INDIAN POINT NUCLEAR GENERATING UNIT NO. 1

AMENDMENT TO PROVISIONAL OPERATING LICENSE

AMENDMENT NO. 9 TO FACILITY OPERATING LICENSE
NO. DPR- 5 CHANGE NO. 65 TO TECHNICAL SPECIFICATIONS;

ENVIRONMENTAL EVALUATION BY THE DIRECTORATE OF LICENSING

Figure 5-1
Organization Chart

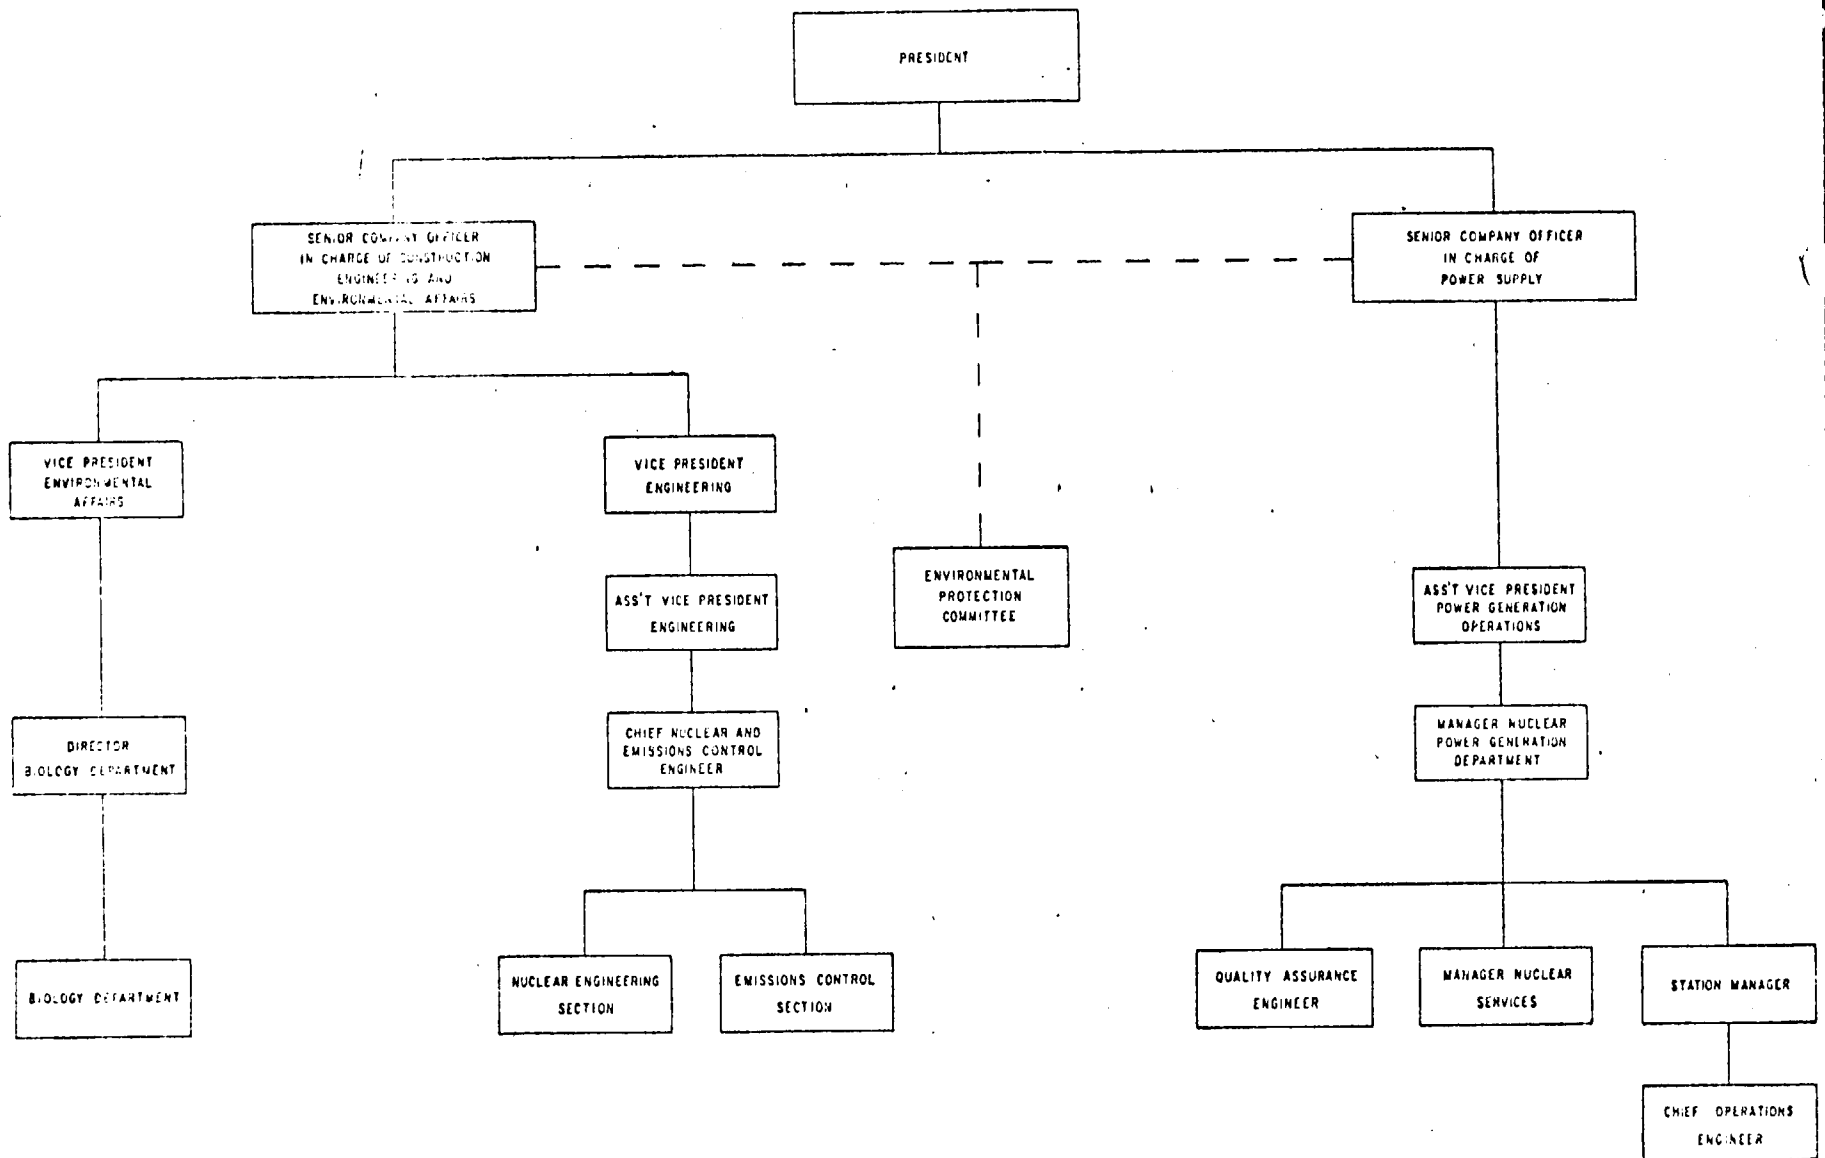
3. The Manager-Nuclear Services shall report to the Manager of the Nuclear Power Generation Department and either he, or his designee, has primary responsibility for the station environmental monitoring. The Chief Mechanical Engineer, who shall report to the Vice President, Engineering, and the Director of the Biology Department, who shall report to the Vice President, Environmental Affairs of the Company, have primary responsibility for execution of special environmental studies. The Chief, Chemical Engineering, who shall report to the Assistant Vice President of Power Generation Operations, has primary responsibility for the chemical engineering operations on site. See Figure 5-1 for an organizational chart.

- D. The Manager of the Nuclear Power Generation Department will inform his supervisor of the abnormal occurrence such that in accordance with Figure 5-1, a Company officer shall report the circumstance of any abnormal environmental occurrence to the AEC within 24 hours; as specified in Specification 5.6 "Plant Reporting Requirements," a written report shall follow within 10 working days. Each such occurrence shall be reported in the routine Semi-Annual Operating Report. 65

As indicated in Figure 5-1 in Attachment I, to assure direct responsibility of the EPC for review and audit of environmental procedures to the Company's management, the EPC provides advice and reports both to the Senior Vice President, Construction, Engineering and Environmental Affairs, and the Senior Vice President, Power Supply.

Figure 5-1
Organization Chart

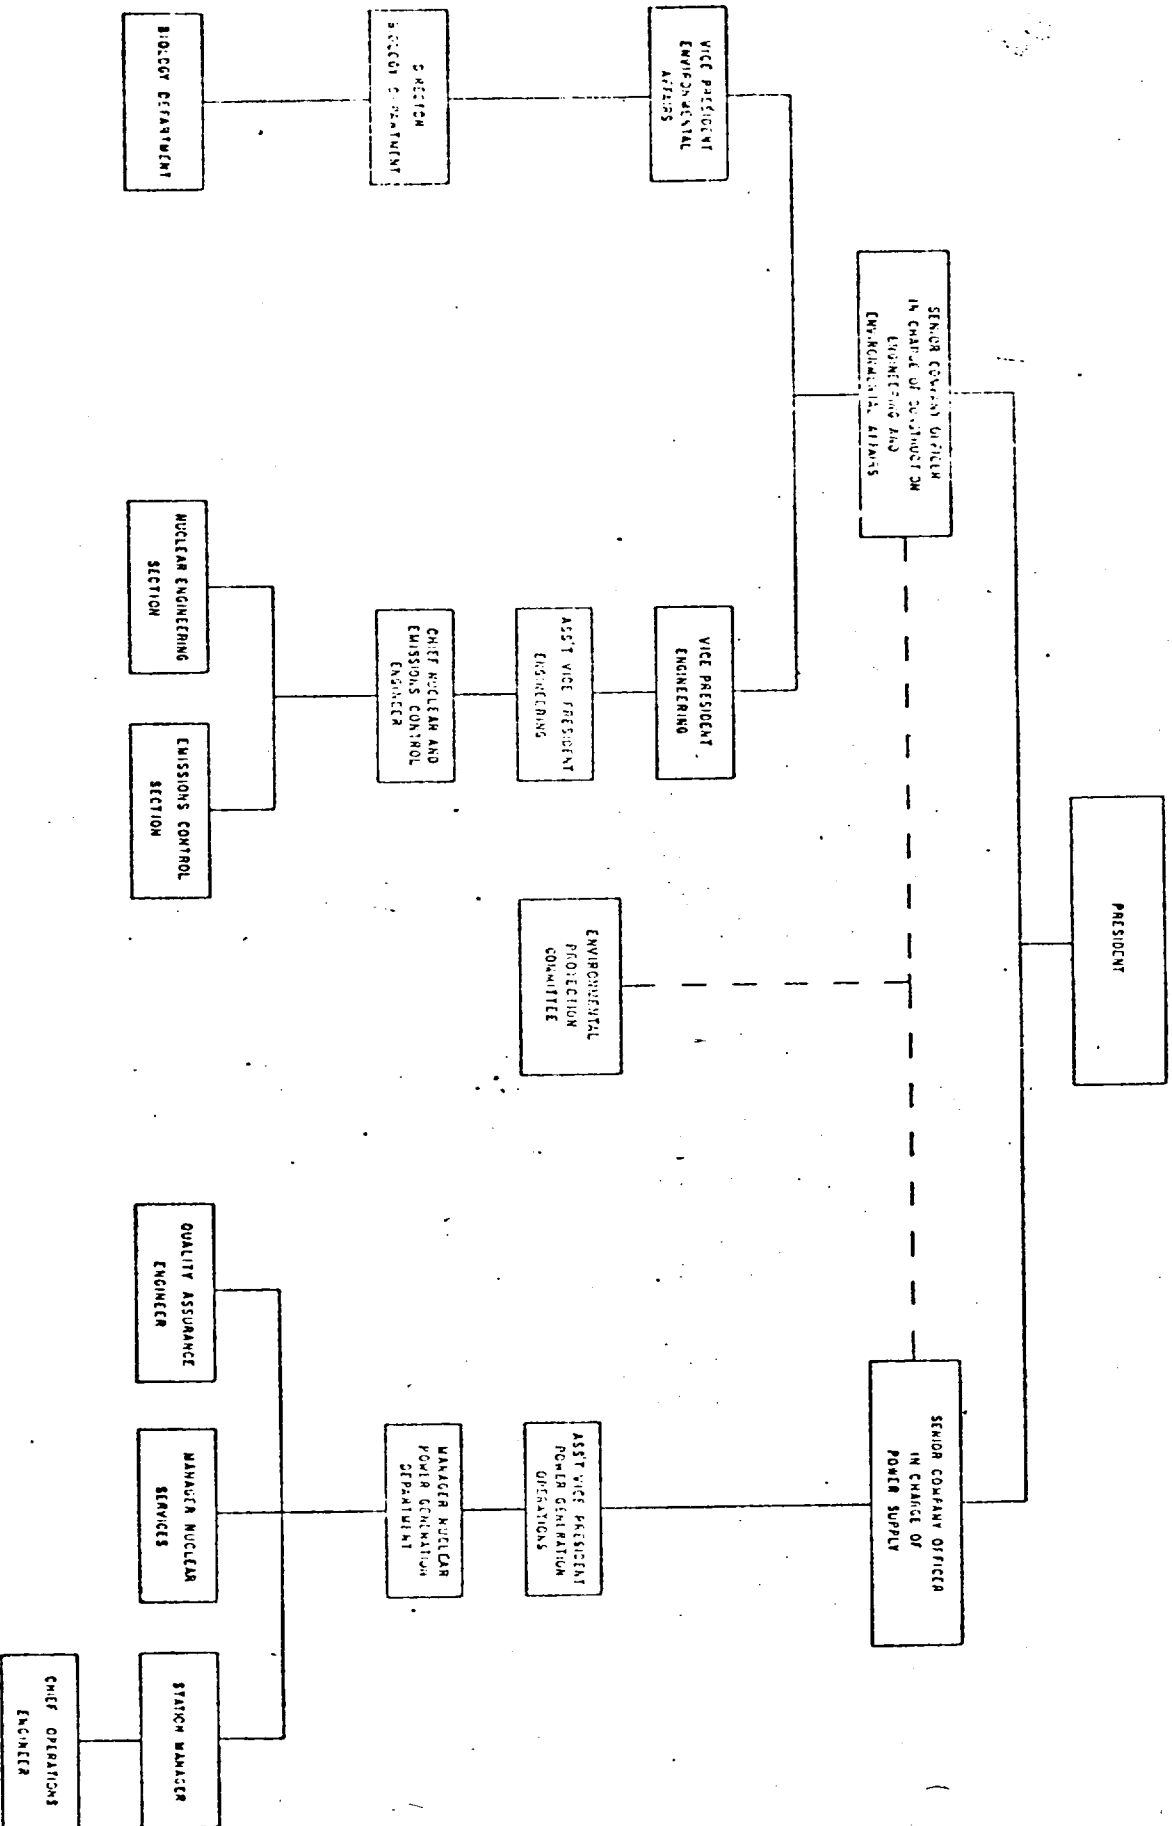
3. The Manager-Nuclear Services shall report to the Manager of the Nuclear Power Generation Department and either he, or his designee, has primary responsibility for the station environmental monitoring. The Chief Mechanical Engineer, who shall report to the Vice President, Engineering, and the Director of the Biology Department, who shall report to the Vice President, Environmental Affairs of the Company, have primary responsibility for execution of special environmental studies. The Chief, Chemical Engineering, who shall report to the Assistant Vice President of Power Generation Operations, has primary responsibility for the chemical engineering operations on site. See Figure 5-1 for an organizational chart.

- D. The Manager of the Nuclear Power Generation Department will inform his supervisor of the abnormal occurrence such that in accordance with Figure 5-1, a Company officer shall report the circumstance of any abnormal environmental occurrence to the AEC within 24 hours; as specified in Specification 5.6 "Plant Reporting Requirements," a written report shall follow within 10 working days. Each such occurrence shall be reported in the routine Semi-Annual Operating Report.
